UNITED STATES PATENT AND TRADEMARK OFFICE

APPLICATION NO.	FILING DATE	FIRST NAMED INVENTOR	ATTORNEY DOCKET NO.	CONFIRMATION NO.
09/988,864	11/19/2001	Jacques Agostini	33900-91	9200

Office Action Summary

DETAILED ACTION

FIG. 2

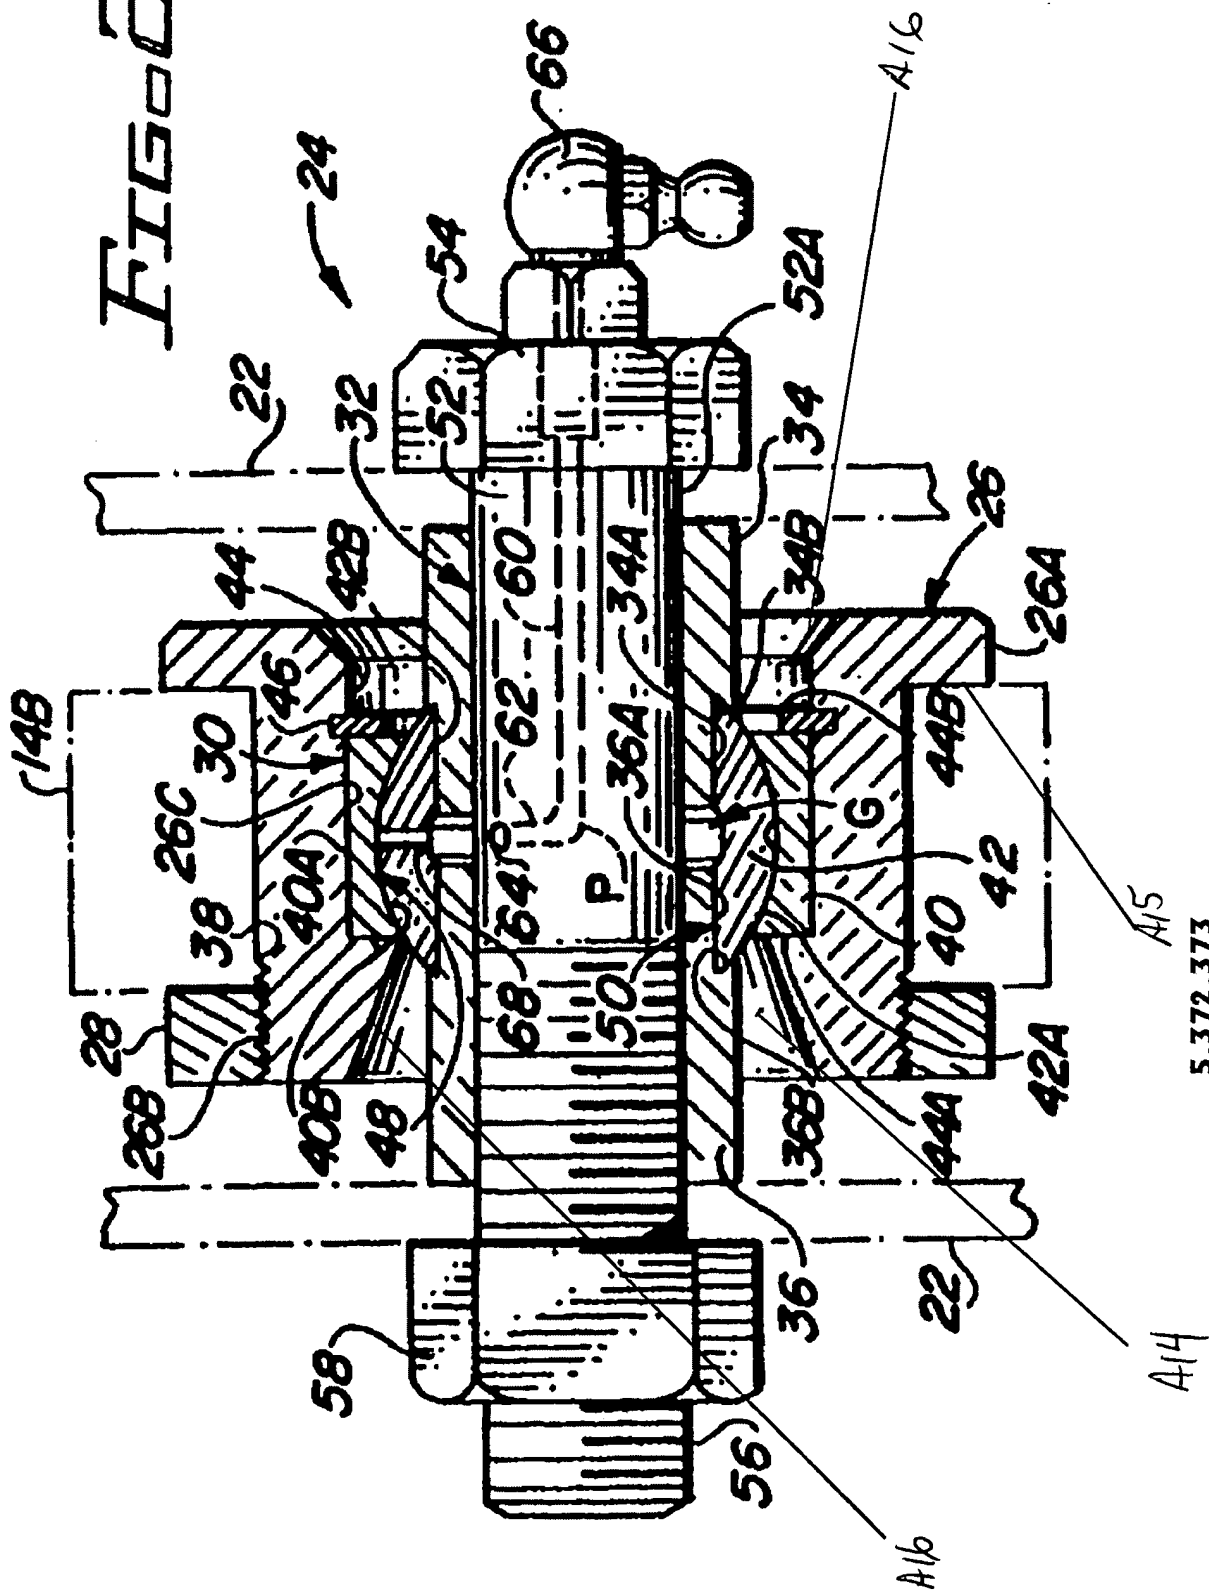
Claims 1-4 and 6-8 are rejected under 35 U.S.C. 102(b) as being anticipated by Reel, 5,372,373 (see marked-up copy).

Regarding claim 1, Reel discloses in Fig. 2 a joint comprising a nut **26**, a ring **42**, and a lock-nut **28**. The nut **26** is provided with an axial cavity **44** presenting spherical walls **40B** opening out in a divergent bore **A4** made inside a threaded sleeve **26B** extending from the nut **26**. The ring **42** comprises a portion of a ball **42** having a spherical wall **42B**.

Regarding claim 3, the ring **42** is tapped. Furthermore applicant is reminded that a recitation with respect to the manner in which a claimed apparatus is intended to be employed does not differentiate the claimed apparatus from a prior art apparatus satisfying the claimed structural limitations. *Ex parte Masham*, 2 USPQ2d 1647 (1987).3.

Regarding 4, the ring **42** comprises a throat **68**.

Regarding claim 7, the nut **26** comprises an annular shoulder **26A** defining a face **A15**.

Regarding claim 8, respective outer lateral edges **A16** of the cavity **44** and of the bore **A4** are beveled.

FIG. 2
PRIOR ART

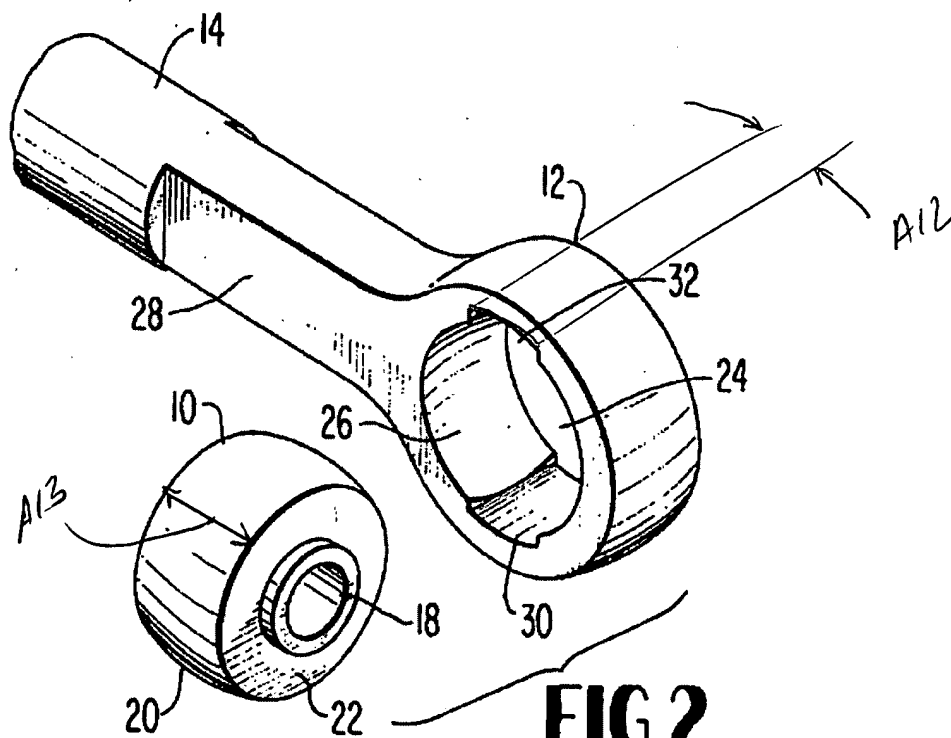
Claim 5 is rejected under 35 U.S.C. 103(a) as being unpatentable over Reel, 5,372,373, in view of Duncan, 3,941,495 (see marked-up copy).

Regarding claim 5, Reel, as discussed above, fails to disclose the cavity **44** comprises two diametrically opposite lateral notches; and each of the notches has a angular length slightly greater than a width of the ring **42**. Duncan teaches in Figure 2, as prior art, a cavity **24** comprising two diametrically opposite lateral notches **30, 32**; and, each of the notches **30, 32** has a angular length **A12** slightly greater than a width **A13** of the ring **42** to facilitate insertion of a ring into the cavity (col. 1, lines 28-34). Therefore, as taught by Duncan, it would have been obvious to one of ordinary skill in the art at the time the invention was made to include two diametrically opposite lateral notches each having an angular length slightly greater than the width of the ring of Reel to facilitate insertion of the ring into the cavity.
